### 10.3 Main Steam Supply System

The information in this subsection of the reference ABWR DCD, including all subsections, tables, and figures, is incorporated by reference with the following departures and supplements.

Figure 10.3-1 Main Steam Supply System

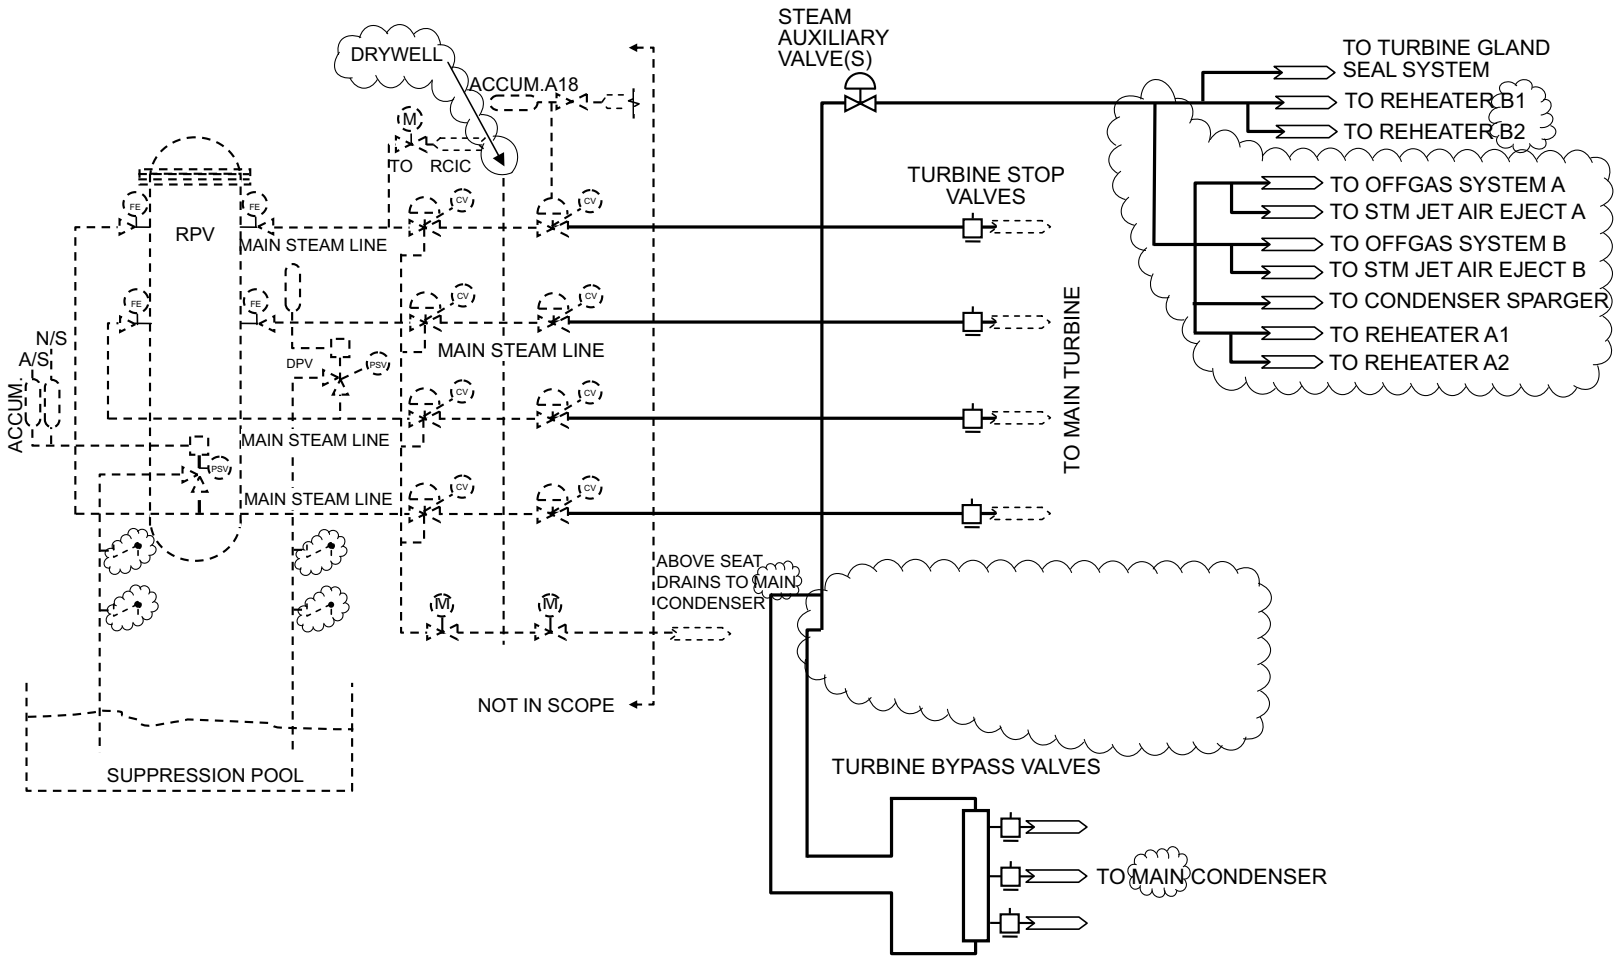
STP DEP 10.2-1 (Table 10.3-1, Figures 10.3-1 and 10.3-2)

*The Main Steam Supply System is illustrated in Figure 10.3-1. The system design data is provided in Table 10.3-1. The main steam piping consists of four 700A pipe size diameter lines from the outboard MSIVs to the main turbine stop valves. The four main steamlines are connected to a header upstream of the turbine stop valves to permit testing of these valves ~~the MSIVs~~ during plant operation with a minimum load reduction. This header arrangement is also provided to ensure that the turbine bypass and other main steam supplies are connected to operating steamlines and not to idle lines. The main steam process downstream of the turbine stop valves is illustrated in Figure 10.3-2.*

Figure 10.3-2 Main Steam Turbine System

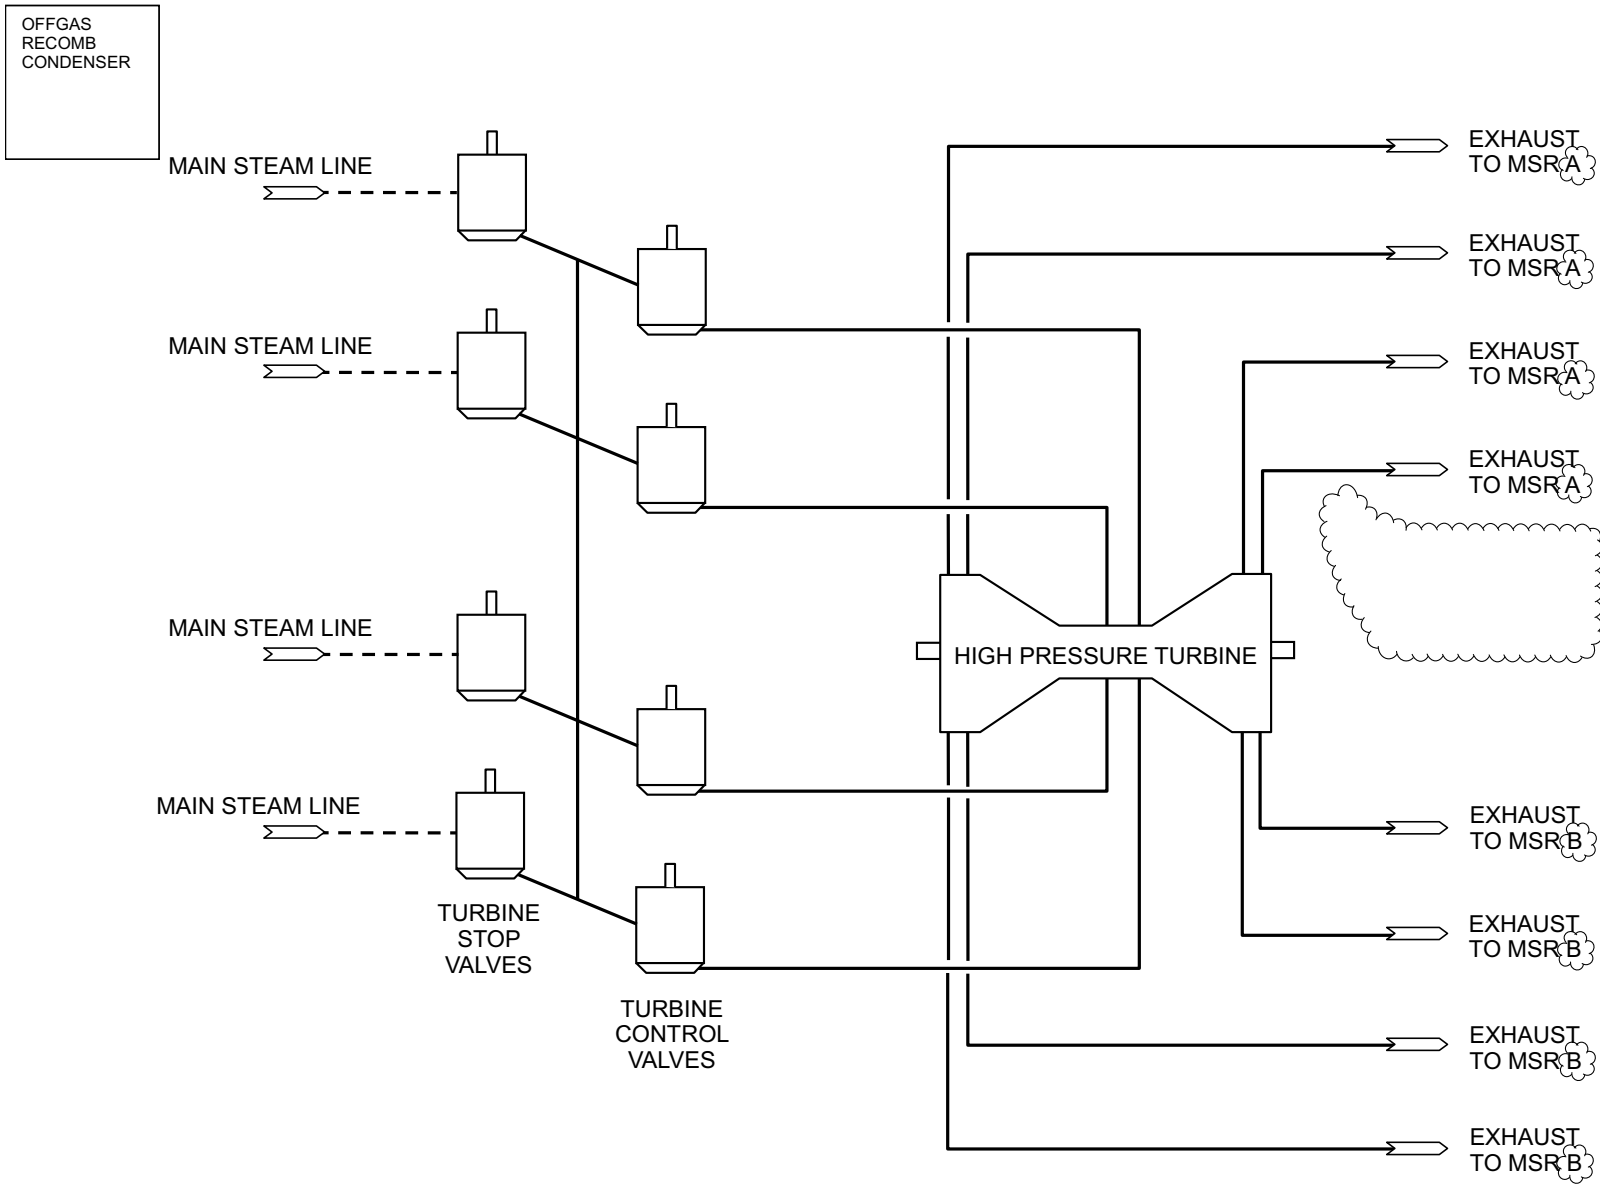
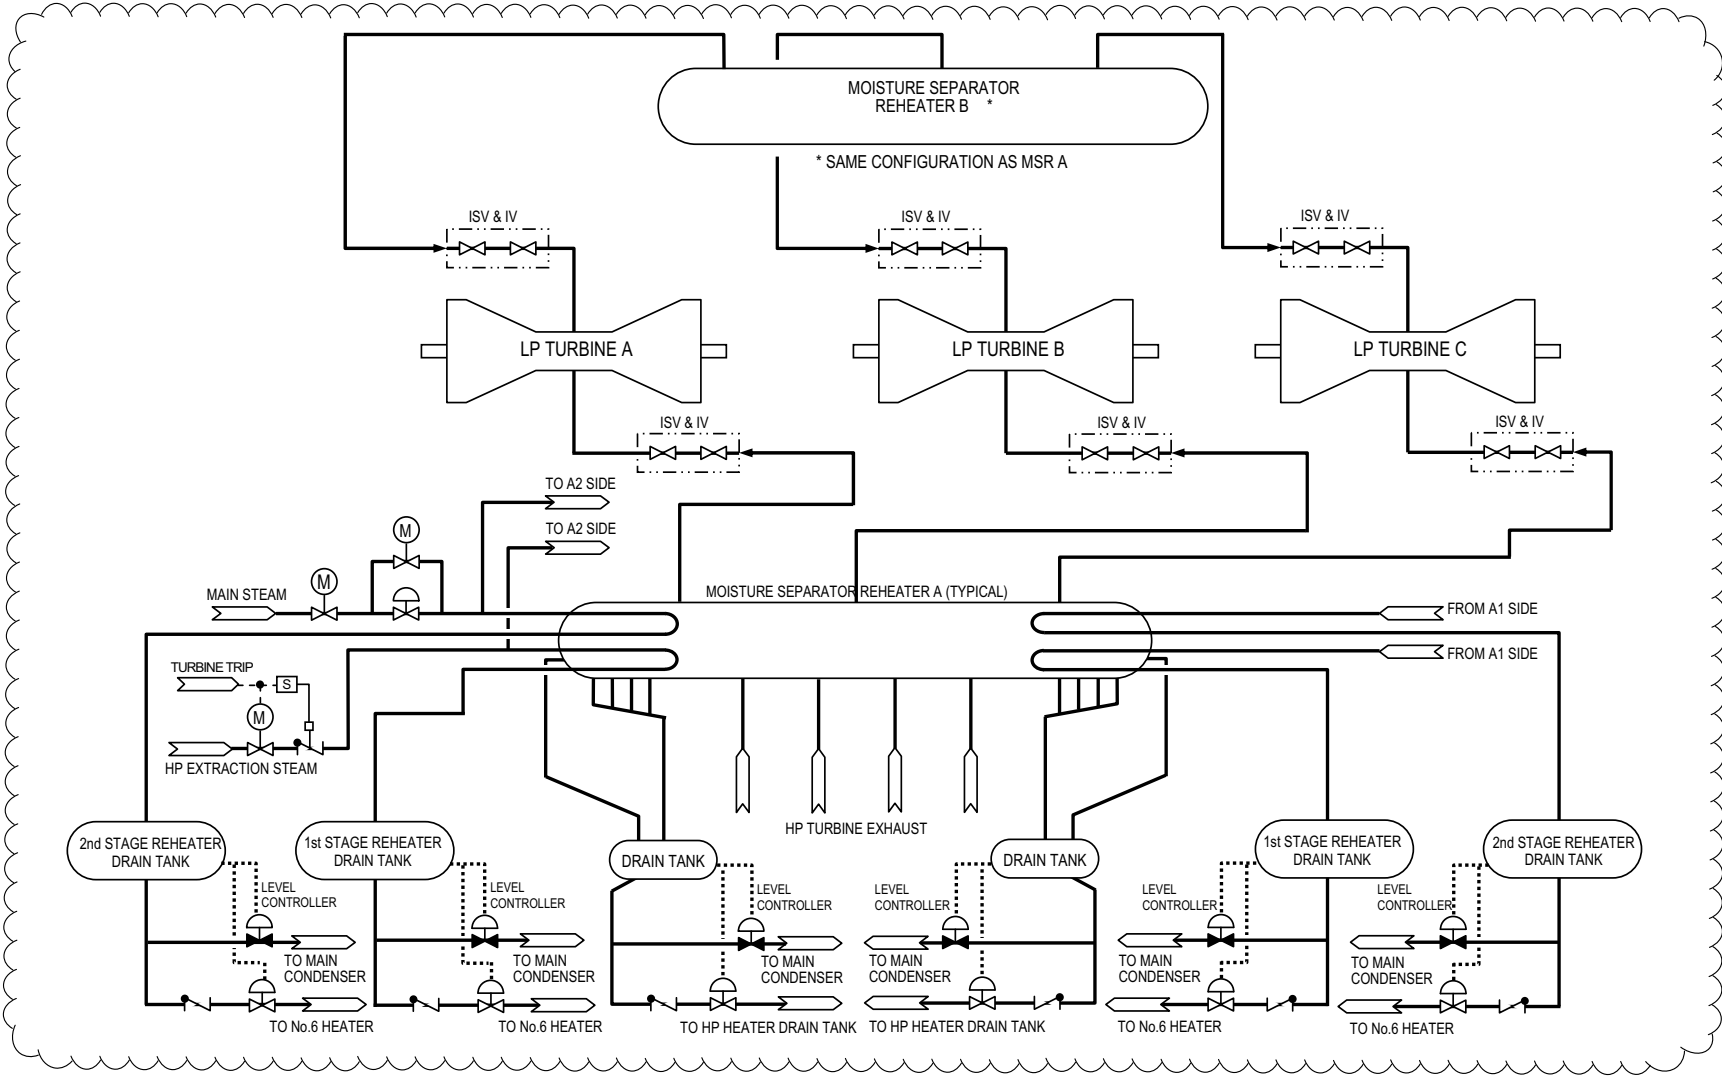
STP DEP 10.4-3 (Figure 10.3-2)
